TECHNICAL REPORT

Response to and Comments on
“Geotechnical Peer Review of Dr. S.
Bernander’s Reports and Analysis of the
North Spur”

This report responds to the statements in the “Geotechnical Peer Review of Dr. S. Bernander’s Reports and Analysis of the North Spur” (GPRP, 2018).

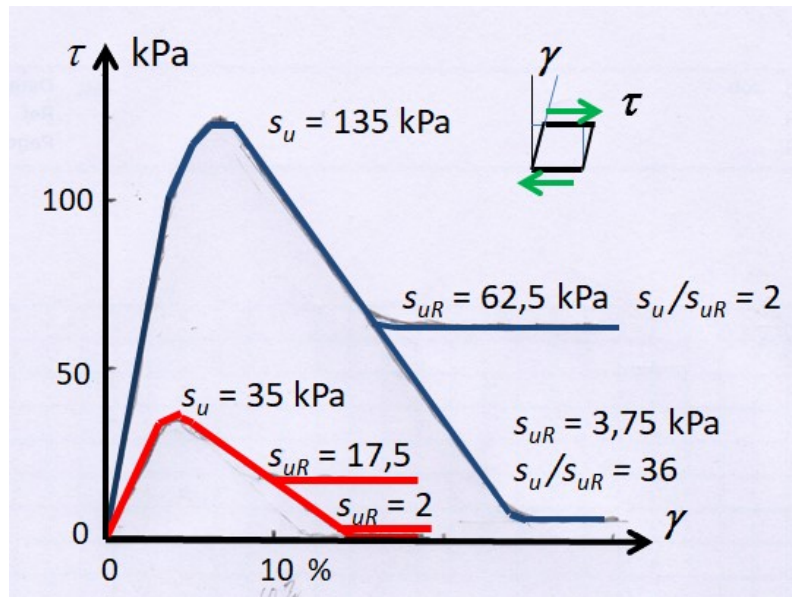
Comment: The main mistake by the GPRP is that it treats the Upper Clay, which has a thickness of up to 15 m, as a homogeneous material. This is by far not the real case. Instead it is composed of layers and lenses of sandy clay, clayey or silty sands, and sand, each with highly varying soil properties, see Figure 2.1.

The *undrained* stress/strain (deformation) properties of the extremely sensitive soil layers have not been defined (as shown in Figure 2.1) and the consequences of this lack of knowledge have not been accounted for.

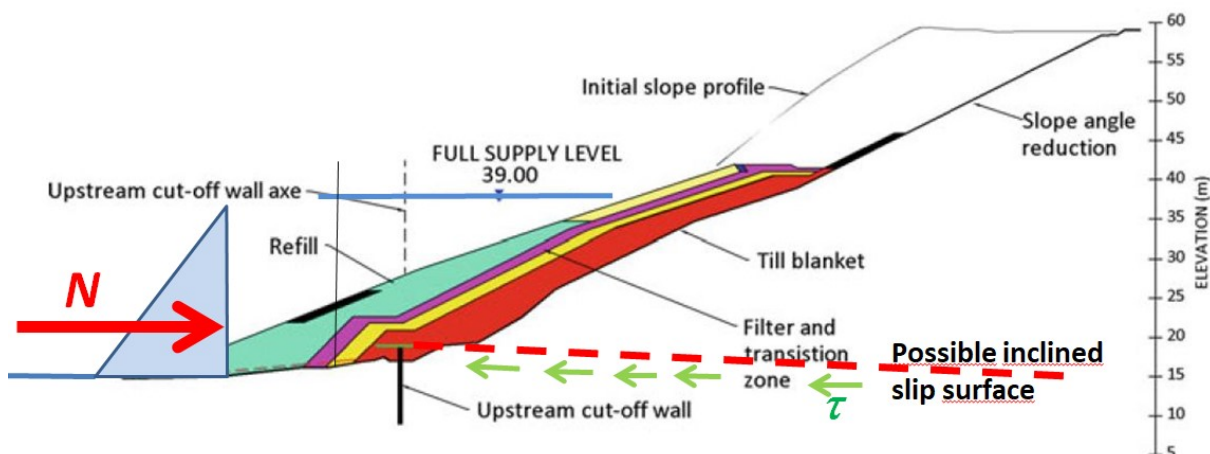
In the current case, a gigantic external force totalling 242,000 kN per 100 m width is applied on the upstream West rim of the North Spur representing an enormous *change* of shear stress and deviatoric deformation.

The effects of this enormous force do not just disappear into *nothing*, see Figure 3.1.

Yet one thing is very *certain*. This force transmission will not, as SLI seems to imagine, adapt to LEM frictional conditions. They will instead be transmitted *by* and *to* very *sensitive soils* that may even have a *potential* to liquefy.

As already dealt with in Section 3, above, the gigantic *external force* totalling 2 420 kN/m being applied on the upstream West rim of the North Spur, represents an enormous *change* of the *shear stress* conditions and of the related *large deviatoric deformations*, see Figures 2.1 and 3.1
